GARDEN SUITES HOT WATER PIPE REPAIRS UNIVERSITY OF CALIFORNIA, MERCED MERCED, CALIFORNIA

Project No.: UCMFAC-17-1520

ADDENDUM NO. 2

April 18, 2017

1. Photos

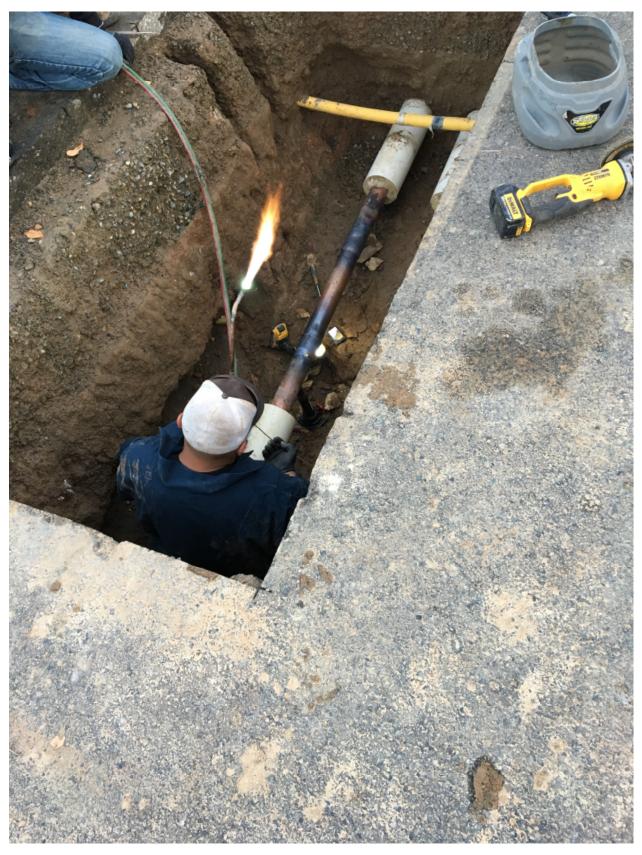
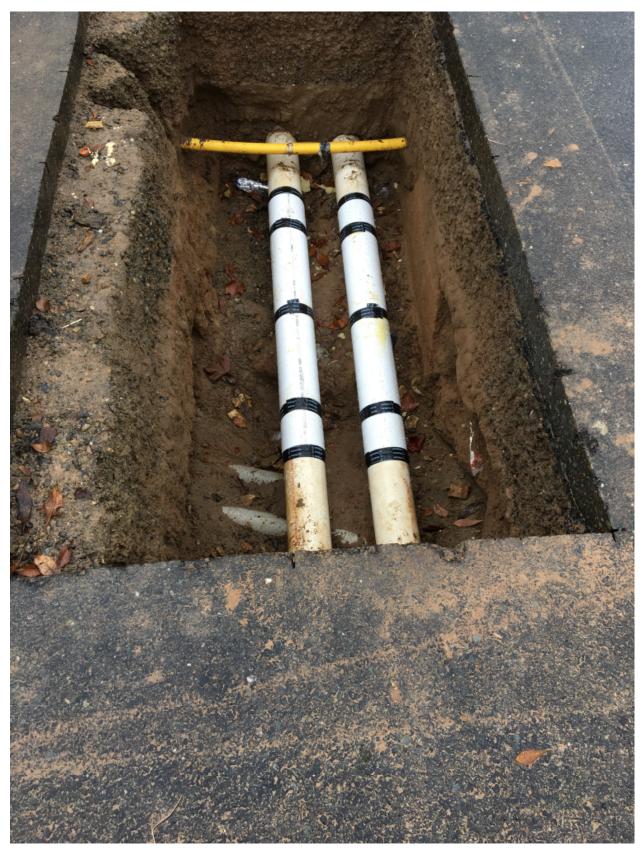
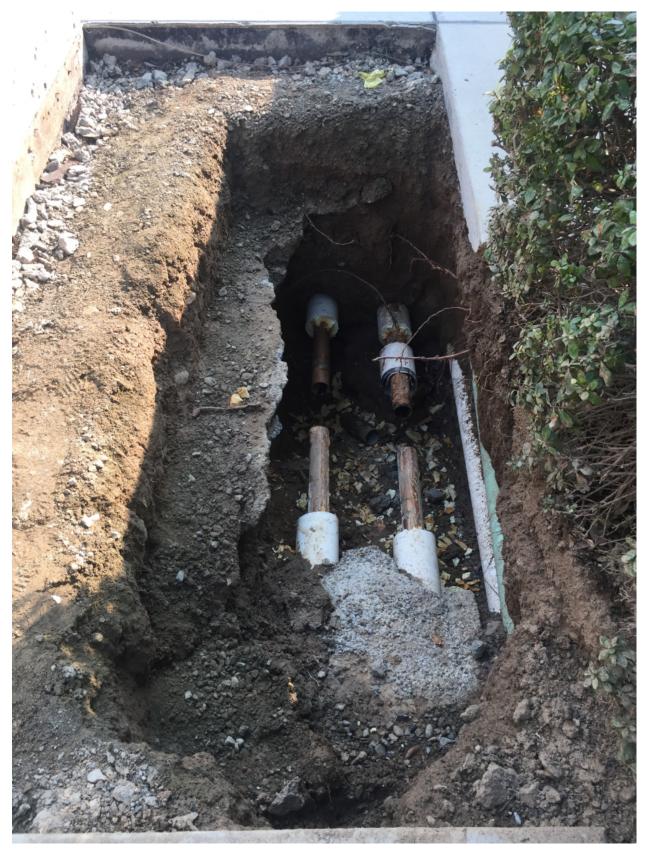
- A. PRE-BID QUESTIONS Questions received from bidders and responses are as follows:
 - 1. Q. Who performed the work that has been complete to date?
 - A. The work was performed by two contractors, Applegate Drilling Co, Inc. and Artisan Design Group, Inc.
 - 2. O. Do you have any information and photos you can provide?
 - A. 9 locations were repaired. 8 were excavated to 3'-6" and one was excavated to 10'. Concrete footings were encountered at 2 locations. Attached are photos.
 - 3. Q. Please clarify testing pressures?
 - A. All work shall be tested to 75 psi, not 150 psi as stated in Addendum.
